SERVICE BULLETIN SB600-2020-1

Inspection of gap between the elevator root hinge assembly and the vertical stabilizer skin.

Fig. 1

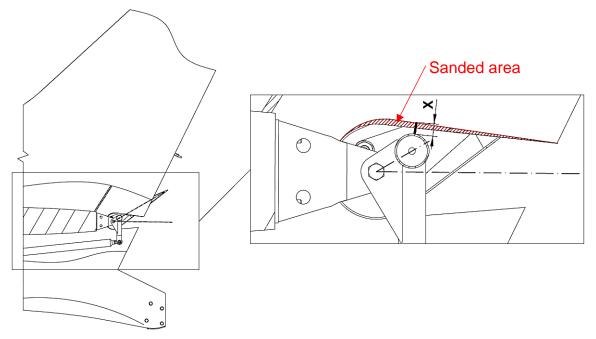
In operation it was observed that the root hinge assembly may come into contact with the cut-out edge of the vertical stabilizer skin at maximum up deflection of elevator. This will result in local minor damage of the skin at the contact point.

- 1. Set the elevator trim to full aft position (aircraft tail heavy) and fix the control stick at the rear stop (elevator deflection 30° up) with the help of an assistant or by other appropriate means.
- 2. Visually inspect the gap "X" between the elevator root hinge assembly and the upper cut-out edge of the vertical stabilizer skin (Fig. 1). The minimum gap "X" is 2 mm.

- 4. Protect the elevator root hinge bearing by appropriate means to prevent debris from getting into the bearing.
- 5. Sand the edge of the vertical stabilizer skin using sandpaper (grit 120) until the prescribed gap "X" is ensured (Fig. 1).
- 6. Clean the sanded area and remove debris.
- 7. Remove the protection of the elevator root hinge bearing.
- 8. Release the control stick from the fixed position.
- 9. Record the compliance with this bulletin into aircraft documentation.
